Intel[®] 80314 I/O Processor Companion Chip

Specification Update

March 2005

Order Number: 273759-008US

Figure 1. Power-Sequencing Requirements

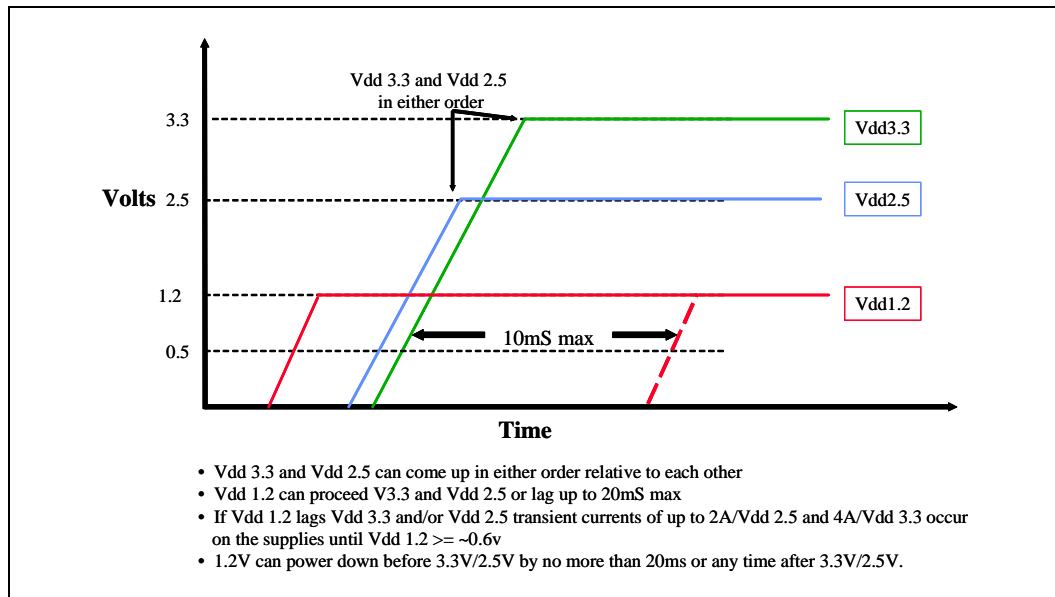
7. Power-sequencing requirement

Issue: The power-up and power-down sequences of the 80314 1.2 V/2.5 V/3.3 V supply rails has been revised from version 003 and 004 of this specification update. The power sequencing requirements initially presented in version 003 were designed to avoid transient current draw that could appear on the 2.5 V/3.3 V supply rails. Further investigation has determined that no current transients occur when the 1.2 V supply is ramped first. In addition, it is acceptable to ramp the 1.2 V supply after the 2.5 V and 3.3 V supplies as long as the lag is less than or equal to 20 mS. When the 1.2 V rail lags the 2.5 V and/or 3.3 V rail, transient currents of up to 2 A/V_{DD2.5} and 4 A/V_{DD3.3} can occur on the supplies until V_{DD1.2} >= ~0.6 V. The 1.2 V supply can power down no more than 20 ms before or any time after the 3.3 V/2.5 V supplies power down. These requirements are illustrated in [Figure 1](#).

Affected Docs: *Intel® 80314 I/O Processor Companion Chip Design Guide* (Section 11.1)
Intel® 80314 I/O Processor Companion Chip Datasheet
